Project	<b>IEEE 802.16 Broadband Wireless Access Working Group</b> < <a href="http://ieee802.org/16">http://ieee802.org/16</a> >	
Title	<b>Comment contribution</b>	
Date Submitted	2002-03-06	
Source(s)	Dave Beyer	<a href="#">Nokia Wireless Routers</a>
	Carl Eklund	<a href="#">Nokia Research Center</a>
	Mika Kasslin	<a href="#">Nokia Research Center</a>
	Nico van Waes	<a href="#">Nokia Wireless Routers</a>
Re:	Ballot 4a	
Abstract	Text corresponding to submitted comments on P802.16a/D2	
Purpose	Consideration & decision	
Notice	This document has been prepared to assist IEEE 802.16. It is offered as a basis for discussion and is not binding on the contributing individual(s) or organization(s). The material in this document is subject to change in form and content after further study. The contributor(s) reserve(s) the right to add, amend or withdraw material contained herein.	
Release	The contributor grants a free, irrevocable license to the IEEE to incorporate text contained in this contribution, and any modifications thereof, in the creation of an IEEE Standards publication; to copyright in the IEEE's name any IEEE Standards publication even though it may include portions of this cont

**Figure 1—MSH-CSCF schedule example**

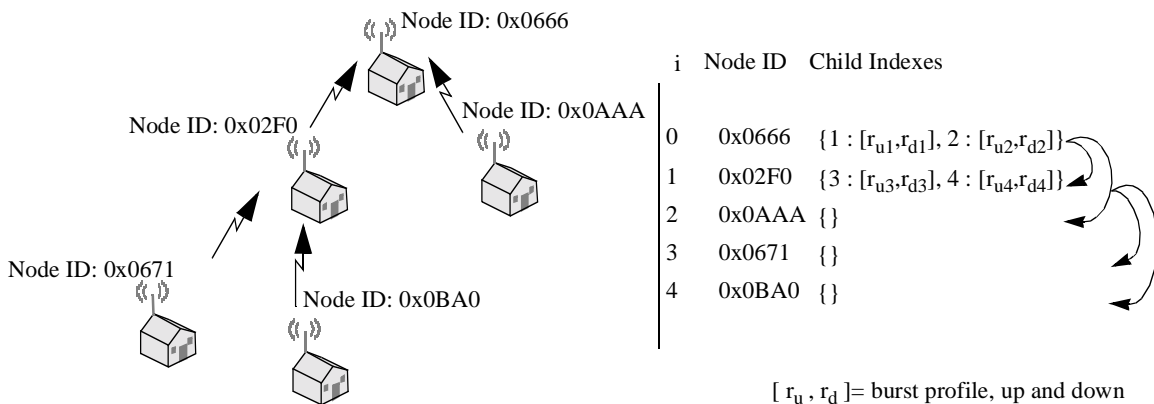
**page 56, line 53, add:**

A simple example of the use of the centralized scheduling flow-mechanism in MSH-CSCF is provided. For the network shown in Figure 2, the requested flows are shown. The data rate is assumed to be the burst profile number (for simplicity) as shown in Figure 1.

**Figure 2—MSH-CSCF flow usage example**

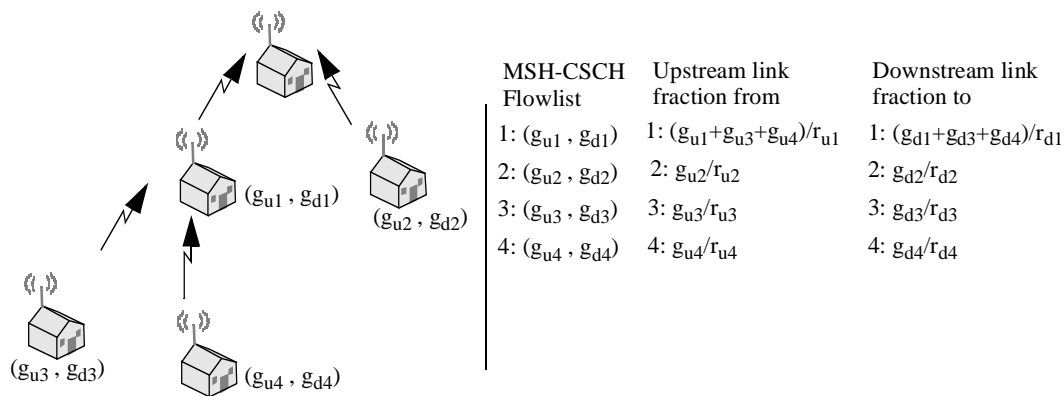
The link fractions shown in Figure 2 are multiplied with  $(2^{\text{FlowScale Exponent}+14})$  and with the frame duration, then rounded up to the nearest duration of a whole number of minislots required to transmit this fraction (including preamble).

**Table 15—Establishing IP Connectivity**

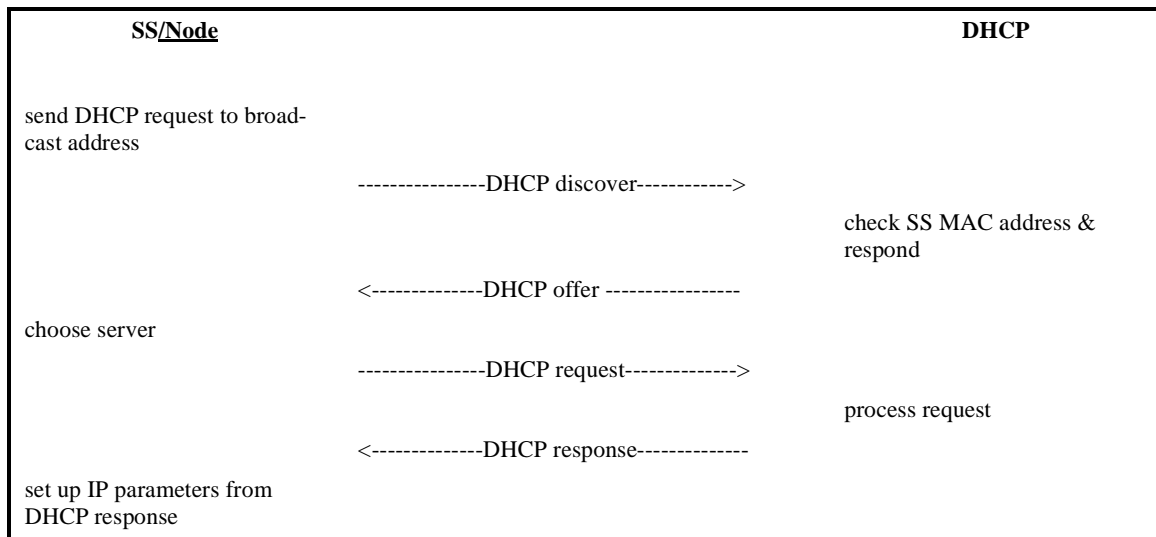
*Change Table 62 as shown in Table 15*

**Figure 231—Channelization, 20 MHz**

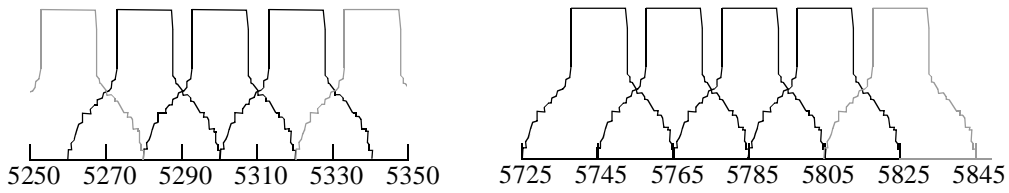
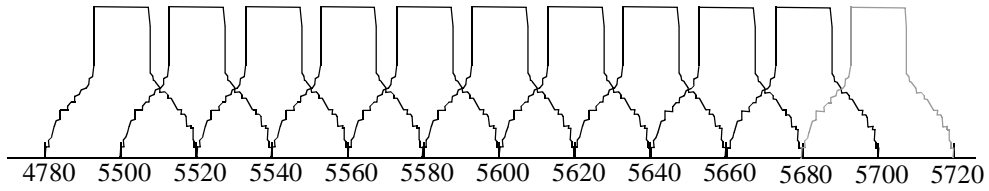
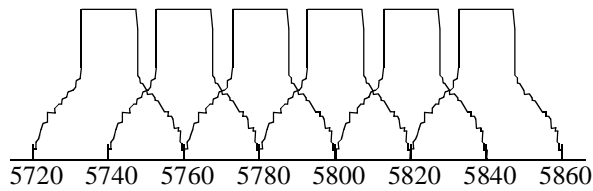
1 | **page 189, line 19, replace figure:**
